PMComanchePeakPEm Resource

Cc: Hill, Craig
Subject: Two Submittals to the NRC
Attachments: TXNB-10070 FSAR UTR R4.pdf; TXNB-10072 RAI 177, 178, 179.pdf

TXNB-10070 FSAR Update Tracking Report Rev 4

TXNB-10072 Responses to RAIs 177, 178, and 179. The RAIs involve communications systems, ITAAC, and paleoliquifaction, respectively.

Figure 9.4-201 UHS ESW Pump House Ventilation System Flow Diagram

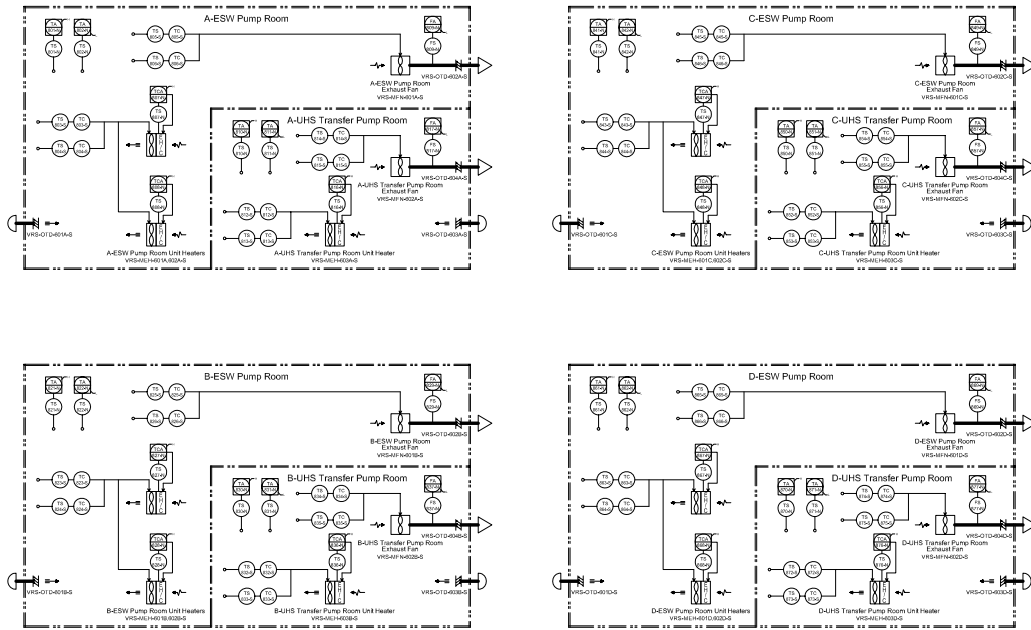
| **CTS-01140**

Figure 11.3-201 Gaseous Waste Management System Piping and Instrumentation Diagram (Sheet 1 of 3)

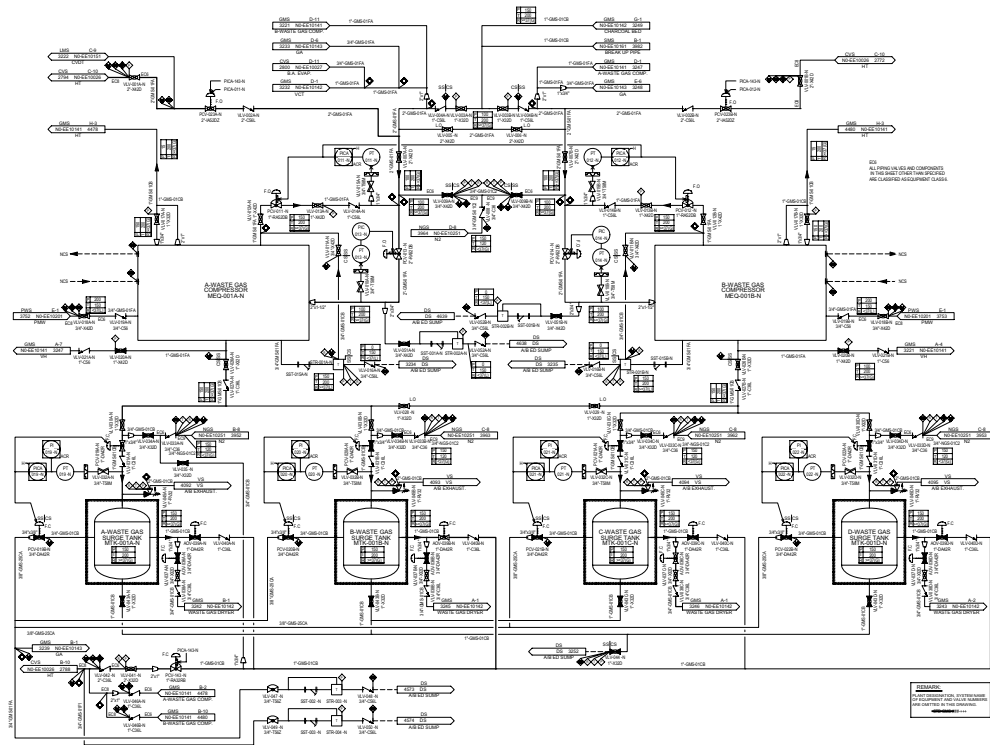
CTS-01140

Figure 11.3-201 Gaseous Waste Management System Piping and Instrumentation Diagram (Sheet 3 of 3)

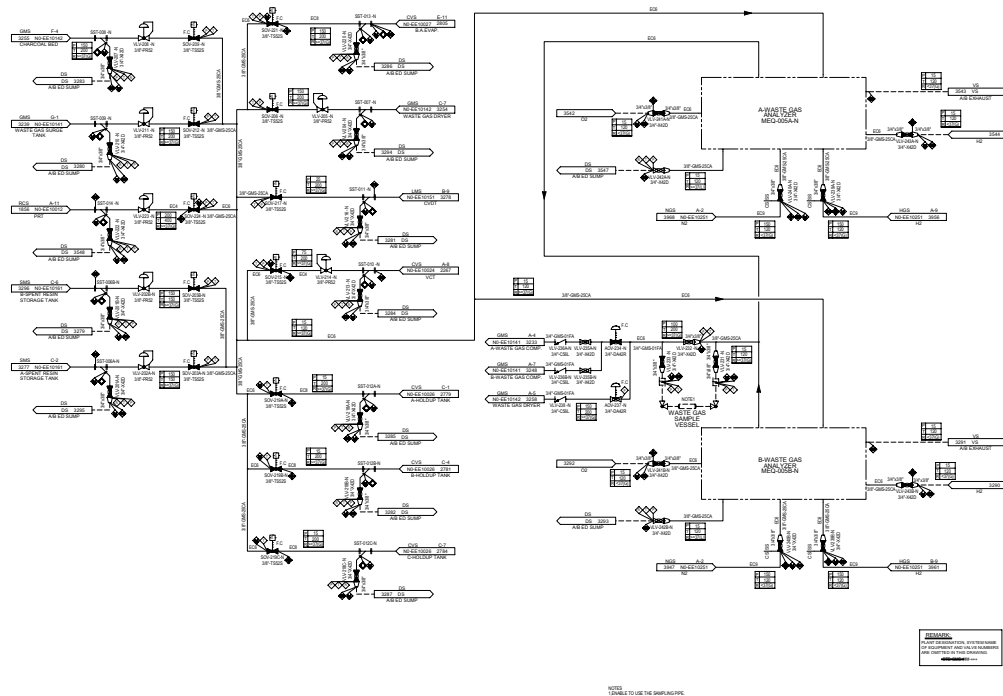
CTS-01140

Figure 11.4-201 Solid Waste Management System Piping and Instrumentation Diagram

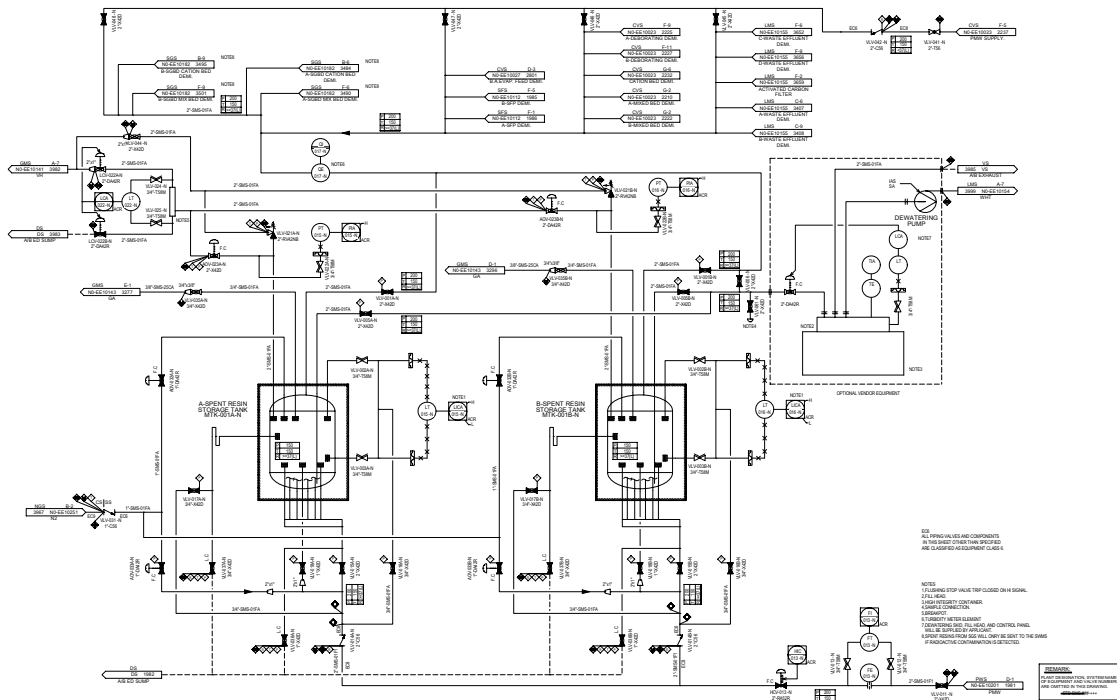
CTS-01140
